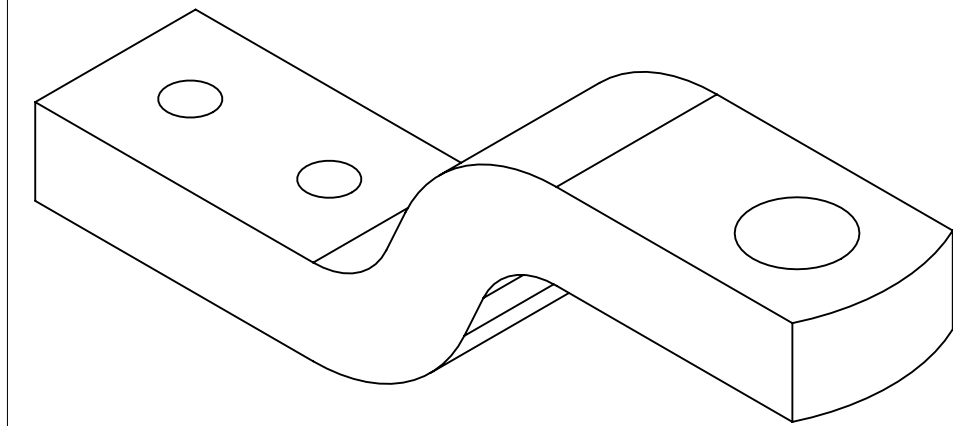
3.DIM R30 ,60 ,24 ,290 WERE CHANGED TO REF. DIM					
ER1810004848	AC	2.TOLERANCE UPDATED FOR Ø 17, 35 ,175 1.DIM 290 WAS 289	AR	NVC	RAW	28/02/18	
600000010304	AB	REDRAWN WITH 3D REF.	VHD	NVC	RAW	03/09/15	
E,R,NO.	LET	LOC	REVISIONS	DSNR	CKR.	APPR.	DATE
